138 South Main Street
 O'Fallon, Missouri 63366
 City of O'Fallon
NEW CITY HALL COMPLEX

**WEST WING
 REFLECTED CEILING
 PLAN**
 CONSTRUCTION DOCUMENTS

Project No. 96036
 Date 4 SEPT 97
 Designed
 Drawn
 Drawing No. **A-59**

N
 ATTIC REFLECTED CEILING PLAN - WEST WING
 SCALE: 1/8" = 1'-0"

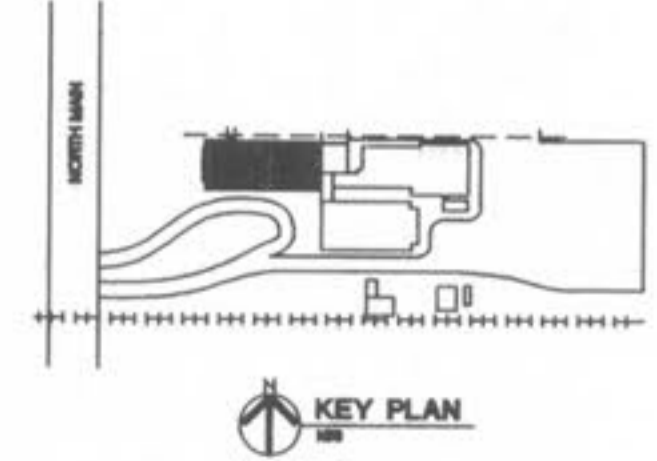
REVISED - SEE ROOF
 PLAN A-5
